**COMMITTEE OF THE WHOLE APRIL 8, 2002**

**SITE DEVELOPMENT APPLICATION DA.01.037  
1315872 & 1327545 ONTARIO LTD.  
REPORT #P.1999.44**

ATTACHMENT '2'  
SITE PLAN

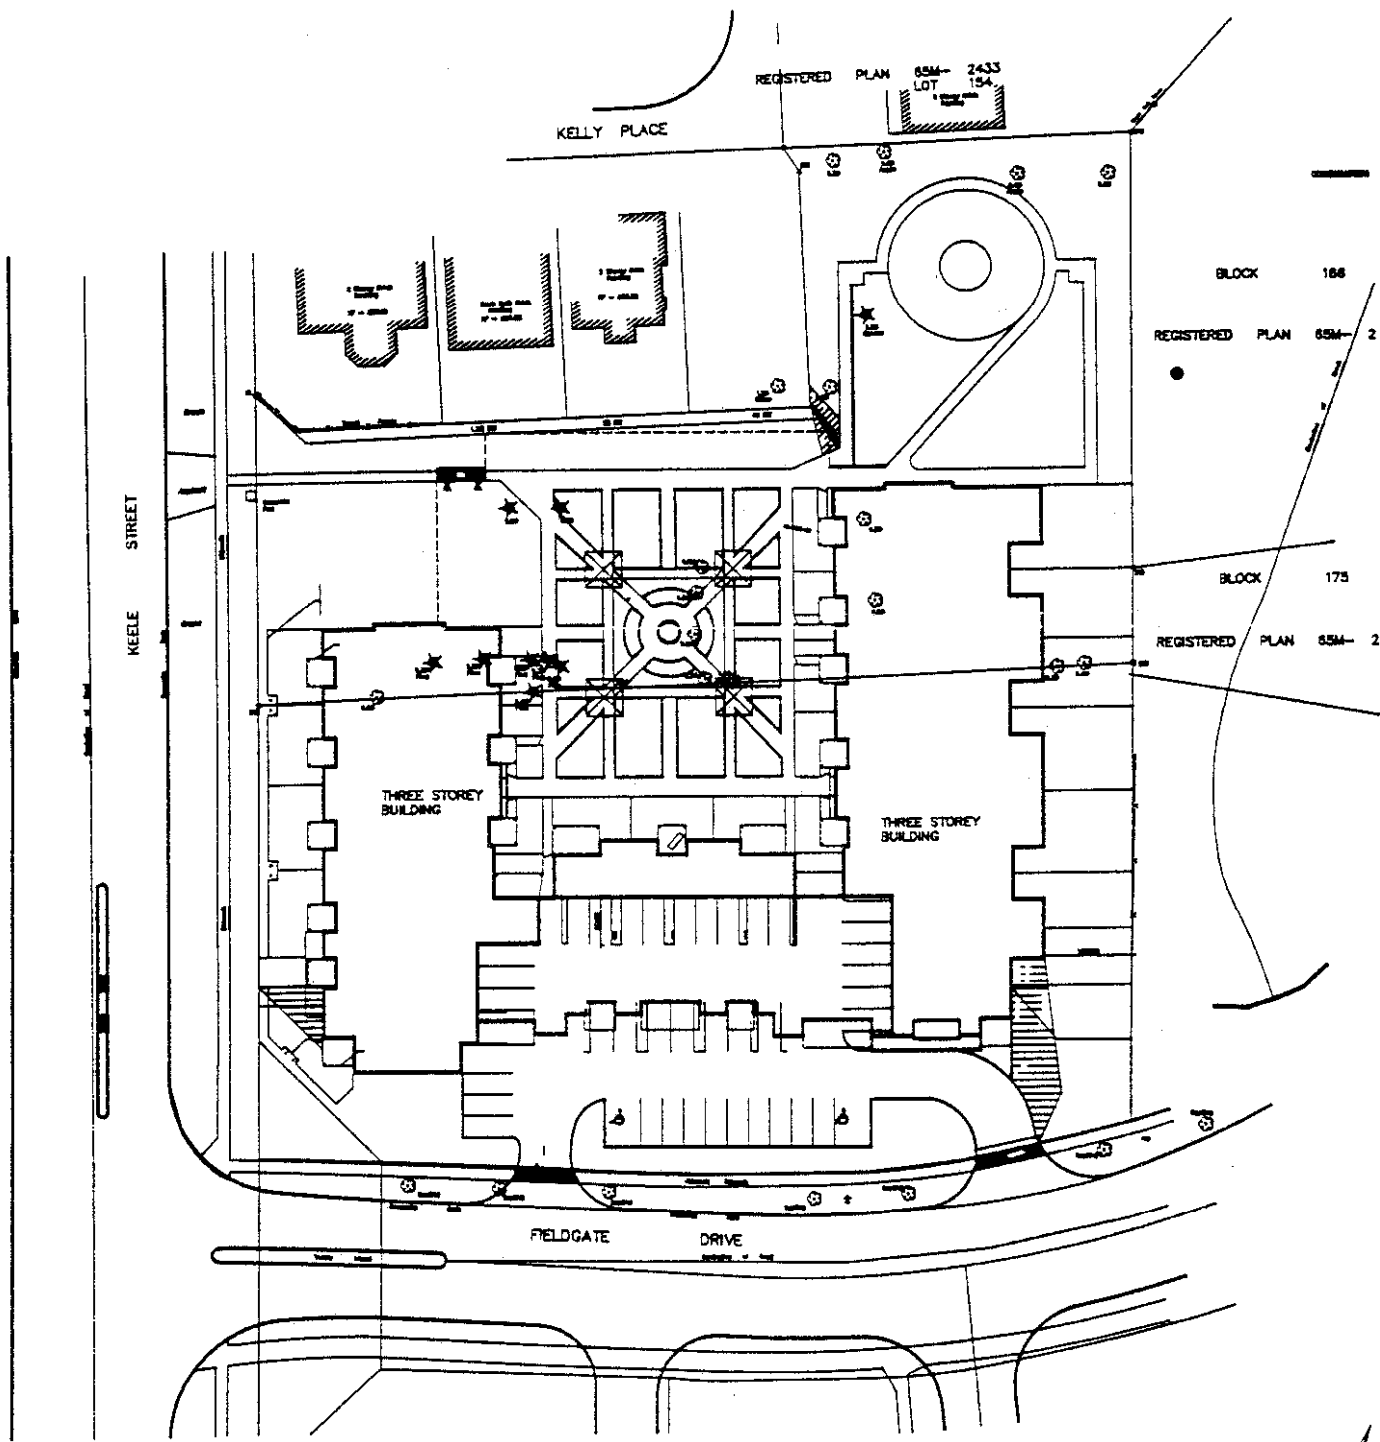
The site plan (Attachment No. 1) consists of a three-storey "U" shaped building, with the two main blocks configured in a north/south direction parallel to Keele Street. The west block is set back approximately 7.9m from the Keele Street property line, and the east block is separated from the existing residential development by a valley system. The west block is set back 25m from the northerly property line abutting residential rear yards. The two blocks are connected at the south end, along Fieldgate Drive, opposite the commercial development.

Pedestrian access to the complex is provided from Keele Street and Fieldgate Drive. Staff recommends that the sidewalk on Fieldgate Drive be extended into the site to delineate a clear pedestrian path to the main entry points of the condominium. All vehicular access is from Fieldgate Drive, leading to underground and surface level parking on the site.

- the wall between the underground and surface level parking areas along Fieldgate Drive should be detailed so it makes a positive contribution to the street; landscaping in the form of evergreens and deciduous shrubs and ornamental trees should be provided at the base of this wall;

- grading information along the east property line should be provided and any construction details (i.e. walls, fencing etc.) be submitted to the TRCA for comments;

- additional shrubs should be provided in the landscape strip along Fieldgate Drive;
- additional information respecting groundcover and quantities in the fountain/piazza area is required;

- additional planting and site layout details should be provided in the area south of the piazza;
- that the site plan agreement require that all existing trees to remain should be well treated and surviving upon completion of the construction process; If not, it is the Applicant's responsibility to plant equivalent caliper tree(s) on the site;

- existing trees intended to remain in the parkette should be identified; this area should have a different variety of plant materials and should have gazebo furniture; details must be submitted;

- snow storage areas should be identified on the plans at a rate of 2% of the total lot area;
- a structural engineer must provide certification at the time of Building Permit application to indicate that the underground garage has been designed to support a soil depth of 1.5m for plant material; and,

| <p><b>ATTACHMENT '3'</b></p> <p><b>ELEVATIONS</b></p> |  | <p>FILE #:</p> <p>DA.01.037</p>                        | <p>REPORT #:</p> |

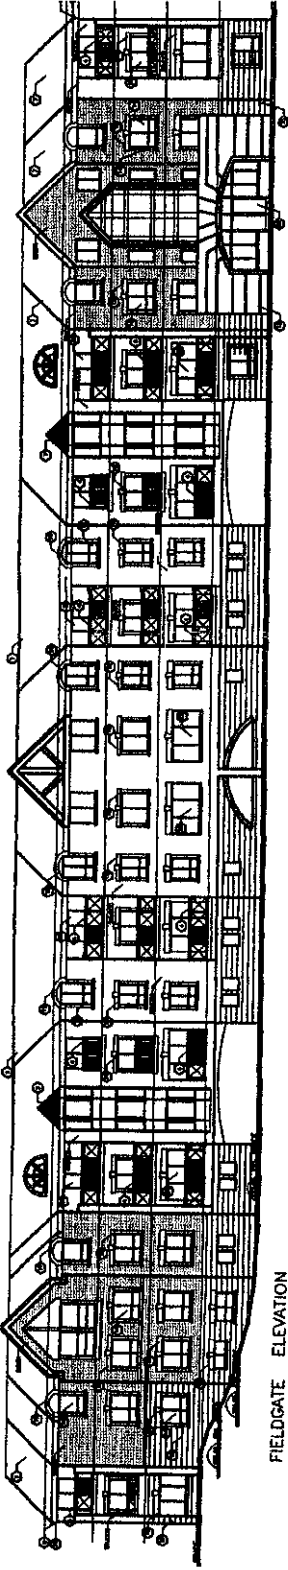
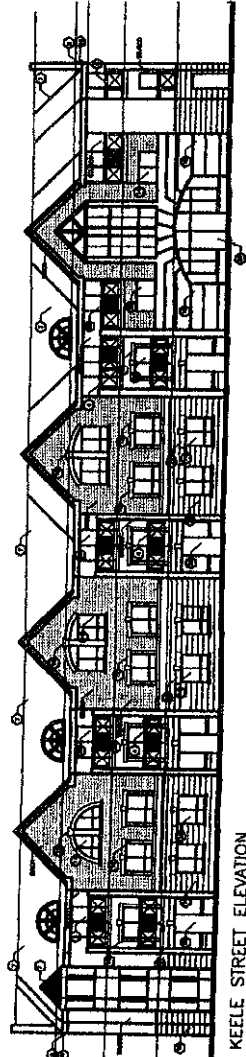
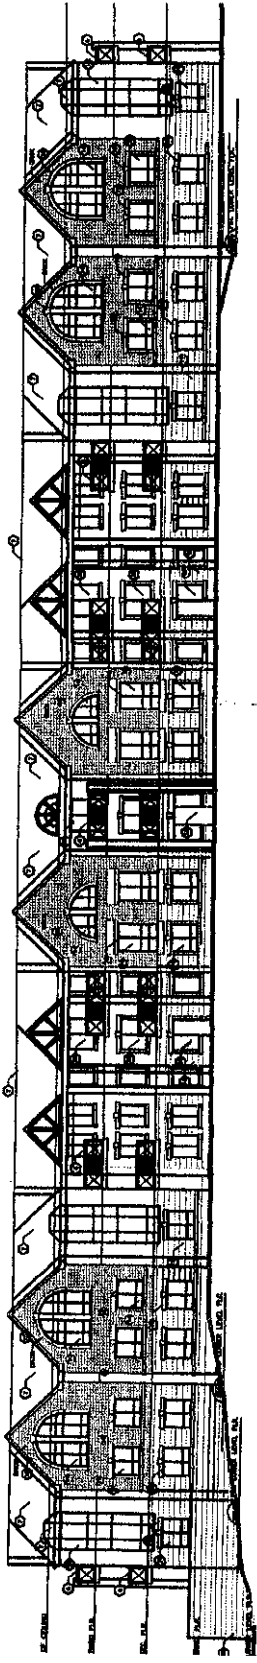
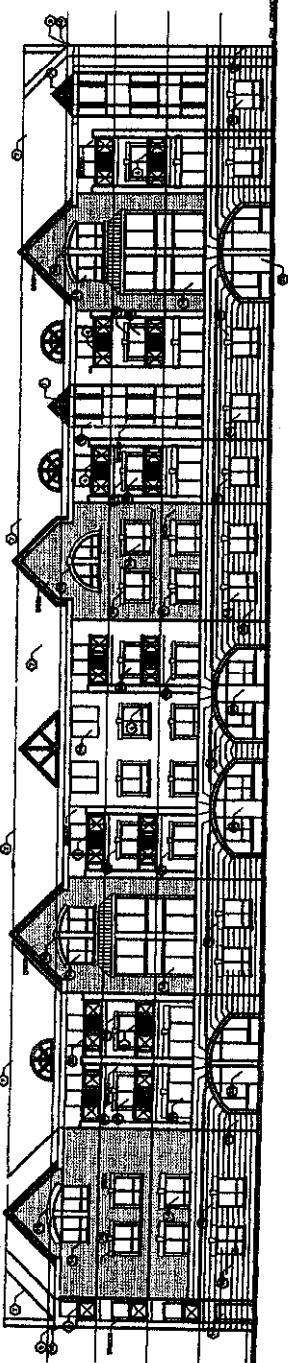
The Keele Street elevation is three storeys in height, as shown on Attachment No. 3. The site slopes downward to the east and consequently, the Fieldgate Drive and east (valley) elevations have a four-storey appearance, at a maximum height of approximately 12.5m.

- the architectural features of heritage structures in the Maple Core (former McNeil House and the Beaverbrook House) be examined and incorporated into the development;
- the proposed stucco be replaced with brick and a more appropriate colour scheme be used;
- the façade on Keele Street be given a more traditional treatment;
- the roofing material include shingles similar to the Maple Core Shoppers Drug Mart;
- the semi-circular shaped roofline and windows be replaced with a more traditional shaped gable roof and dormer;
- the “mall-like” entranceway be replaced with a more traditional heritage design;
- a traditional window design (2 over 2 pane arrangement or double-hung window design, etc.) be used.

- that brick and stucco be used, and that detailing be provided around the windows and doors;
- that the roofing material be “chateau-look” asphalt shingles;
- that the ground floor units on Keele Street be treated as fronts with front entrances and front yards;
- that no steel materials be used on the roof or as building cladding;
- that the wrought iron balcony be designed to include greater variation;
- that the stucco be of earth-tone colours range;
- that consideration be given to screen the east wall with landscaping; and,
- that the MSCAC generally supports the recommendations made by Heritage Vaughan.

Staff recommends that the balconies on the outer perimeter of the building be redesigned to form part of the unit, such as an enclosed solarium. Open balconies tend to become outdoor storage areas for household items and can become unsightly, which is not desirable on an arterial road.

The Urban Design Department has advised that they are generally satisfied with the revised elevations however, have recommended that changes be made to the Fieldgate Drive elevation to reconfigure the parking area located under the second floor of the building. The Urban Design Department has also requested that the Applicant address the landscaping and architectural treatments of the front yards of those units on Keele Street.

- brick sections have been introduced into the elevations on an alternating basis with the stucco;
- the semi-circular roof design has been replaced with traditional peaks;
- brick accent bands have been provided around all the windows and doors; and,
- large picture windows have been replaced with smaller multi-pane windows.

ATTACHMENT '4'  
PROPOSED REVISION TO BY-LAW

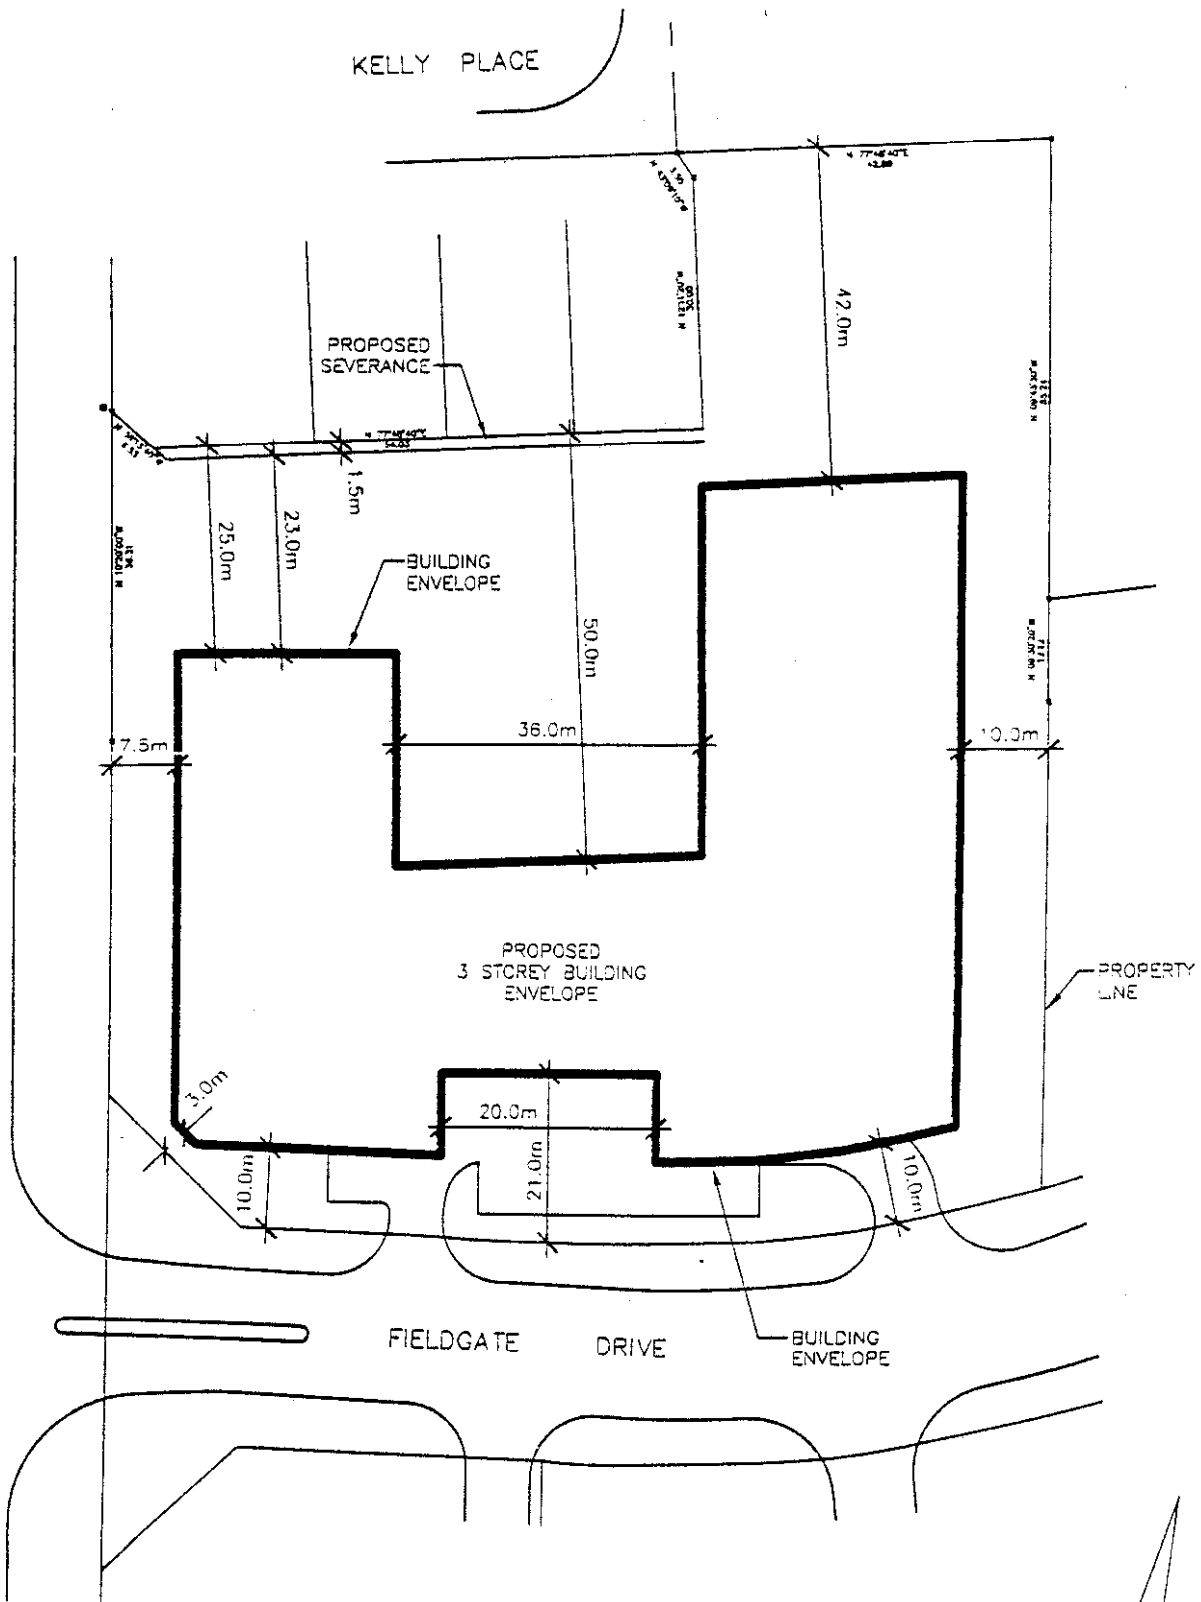
By-law 442-2000 was drafted on the basis of an earlier iteration of the site plan. The revised site plan shows the building within the envelope established in the By-law. The Building Standards Department has identified the following zoning compliance issues that must be addressed prior to the registration of the site plan agreement:

- a 3.0m setback is required from the site triangle;
- a 21.0m setback is required from Fieldgate Drive to the line of the building above;
- a minimum unit size of 80m<sup>2</sup> is required;
- a maximum of 100 units is permitted whereas the floor plans illustrate 101 units;
- the minimum amenity area must be illustrated on the plan;
- all parking spaces must be dimensioned and the tandem parking spaces require an exception;
- 175 parking spaces are required; 155 spaces are provided
- a 3.0m landscape strip is required around the outdoor parking area; and,

A majority of these issues can be addressed either through minor revisions to the proposed plan or by additional information on the drawings. The revised plans address some of these issues, and the remaining exceptions can be identified upon a full zoning review of the final plan. Accordingly, if compliance with certain standards cannot be achieved, and provided the City is satisfied that the intent of the plan is being maintained, the OMB should be requested to modify By-law 442-2000, including Schedule "1" (Attachment 4), as required, to implement the final plan.

- i) an amendment to By-law 422-2000 to include a minimum parking standard of 155 spaces (including 8 tandem spaces), or the minimum number of parking spaces recommended by the approved parking study, whichever is greater;
  - ii) an amendment to Schedule "1" of By-law 422-2000, in the manner shown on Attachment No. 4; and
  - iii) any further zoning amendments as may be required to implement the final approved site plan.
4. That the Ontario Municipal Board be advised of Council's endorsement of the matters contained in Condition 3.
